Service Bulletin N° 97

SUBJ: X-Wing Motor Bushing

X-Wing Drive (Motor) Assembly, 500-6175-00-56 Bushing Reference

Fig. 1

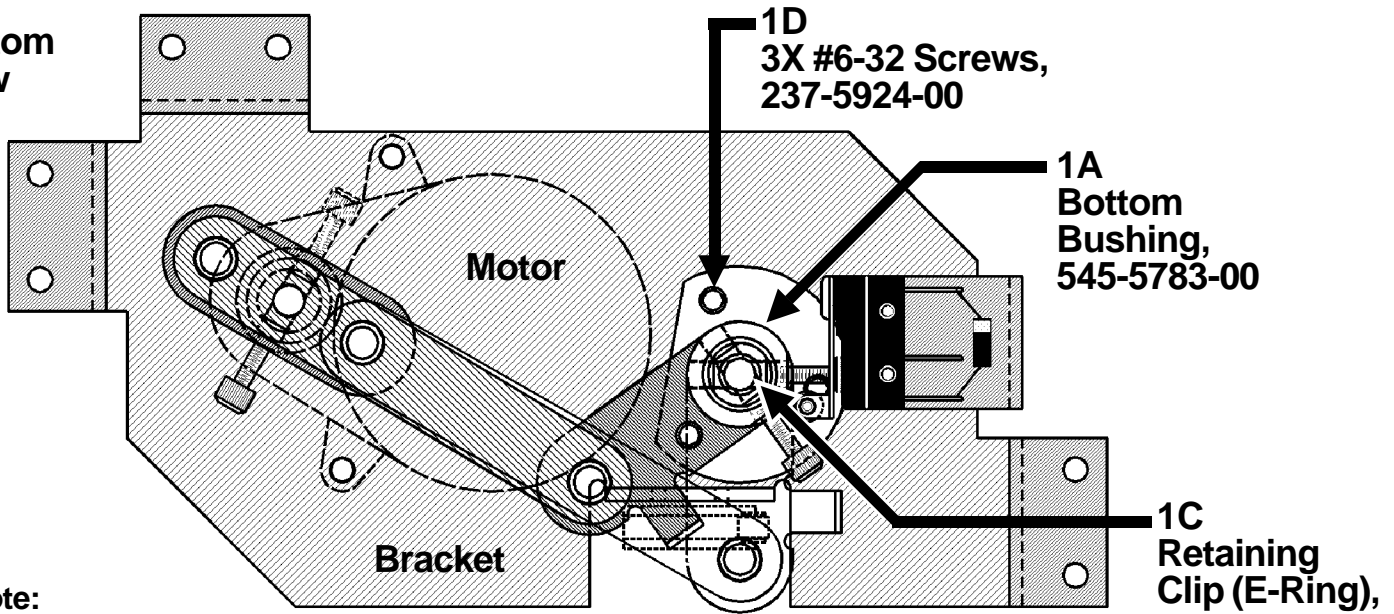
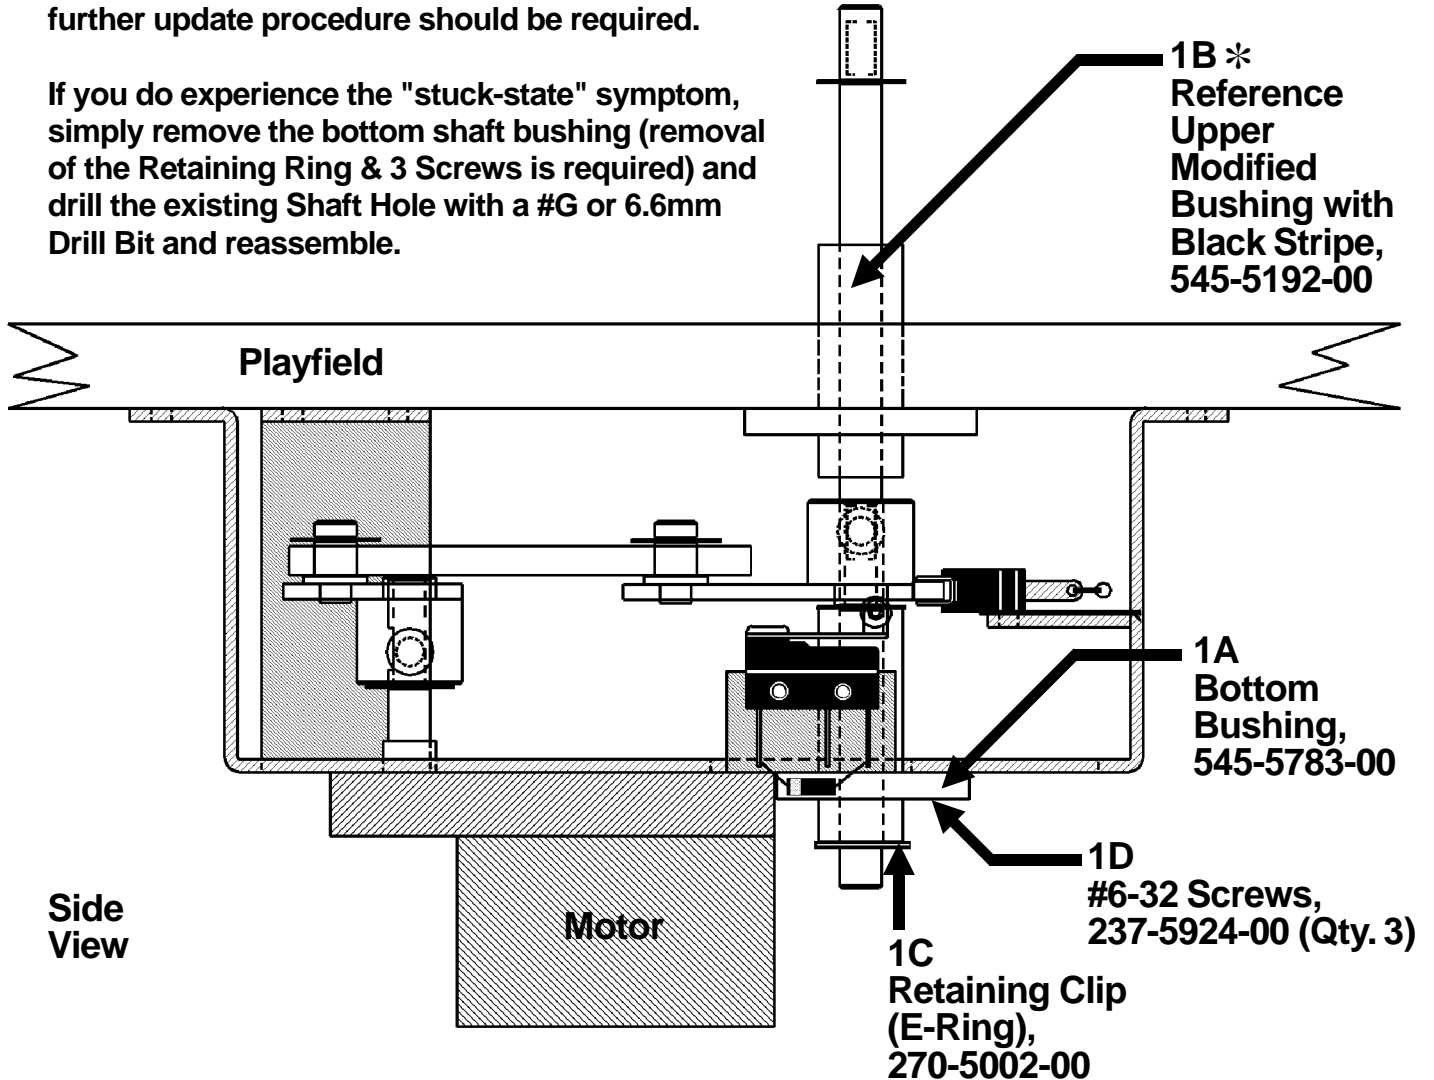
Sometimes at the start of the X-Wing Multiball Feature with the ball loaded into the Cannon, the X-Wing Assembly may not move. This does not necessarily mean the motor has failed; it is simply in a "stuck-state." The *slightest tap or nudge* to the game will start the X-Wing to move again. **If you should experience this symptom please refer to the procedure below.**

Due to slight variances in spotting the X-Wing Assembly while mounting it to the playfield, the shaft bushings (**See Fig. 1**) can cause some binding to the motor shaft. Increasing the inside diameter of *either* shaft bushing (**See Fig. 1A & 1B**) will correct this problem. For simplicity in this correction we recommend fixing the bottomshaft bushing (**See Fig. 1A**). (**See Note below.**)

As stated, there are 2 X-Wing Shaft Bushings, one (1) on the X-Wing Motor Assembly (**See Fig. 1A**) and one (1) on the Upper Motor Shaft on the playfield side (**See Fig. 1B**). **All games made after Serial N° 138041 have been modified and should not experience this "stuck-state" symptom.** The bushing mounted on the playfield side will have a black stripe indicating this (**See Fig. 1B**). **Unless your game is experiencing the above symptoms disregard the above procedure.**

The manual pointed to the wrong bushing. The bushing referenced, 545-5783-00, is mounted on the bottom end of the motor shaft next to the motor. The upper bushing the "manual points to" is 545-5192-00 & is not included with the X-Wing Motor Assy., 500-6175-00-56.

If the Upper Bushing has a black stripe, you should not experience any "stuck-state" symptom and no further update procedure should be required.

- 1 Locate the X-Wing Motor Assembly Bottom Shaft Bushing, 545-5783-00, on the bottom side of the playfield (**See Fig. 1A**).
- 2 Locate and remove the Retaining Clip (E-Ring), 270-5002-00, located at the base of the X-Wing Shaft (**See Fig. 1C**).
- 3 Remove the three (3) #6-32 X 1/2" HWH TF Mounting Screws, 237-5924-00, securing the Bushing to the X-Wing Motor Bracket (**See Fig. 1D**).
- 4 Remove the Bushing from X-Wing Motor Bracket (**See Fig. 1A**). Using a #G or a 6.6mm Drill Bit, enlarge the existing Bushing Shaft Hole. Reassemble.

If you do experience the "stuck-state" symptom, simply remove the bottom shaft bushing (removal of the Retaining Ring & 3 Screws is required) and drill the existing Shaft Hole with a #G or 6.6mm Drill Bit and reassemble.
